ADDENDUM NO. 3 TO PROJECT NO. 44811

**REPLACE THE HVAC SYSTEMS, BUILDINGS 29 AND 66
INDUSTRY LIMITED SECURE CENTER
375 RUSH-SCOTTSVILLE ROAD
RUSH, NY**

March 6, 2015

DWG NO:
SKH-1

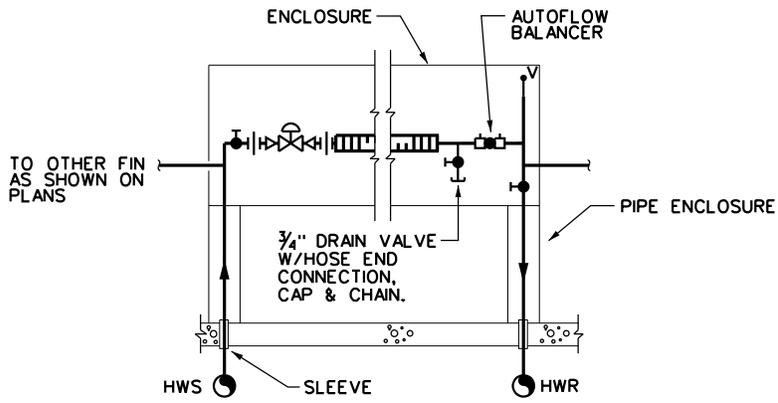
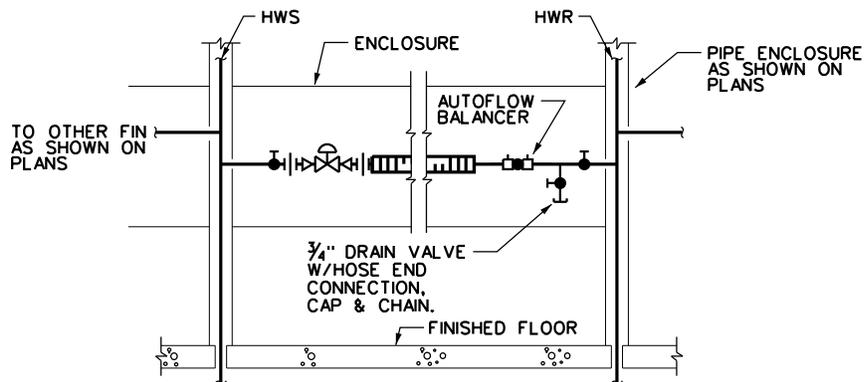
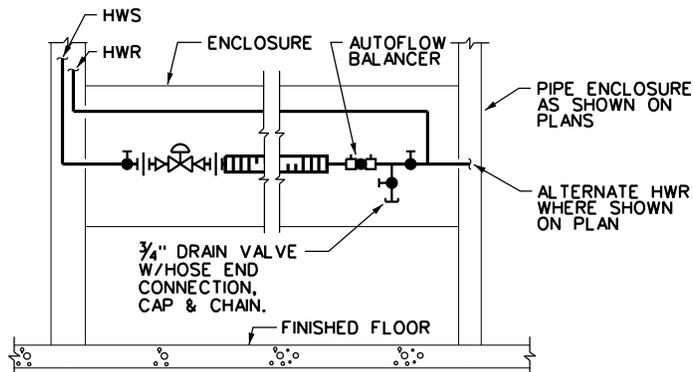
4. Refer to Drawing M-116 - Building 66 - First Floor Plan - HVAC:
 - A. At Men 105, add EF-10 with Note 6.
5. Refer to Drawing M-503 - Details:
 - A. Add fin radiation piping details on Sketch SKH-1 included with this Addendum.

SHEET TITLE: FIN RADIATION PIPING DETAIL
HOT WATER
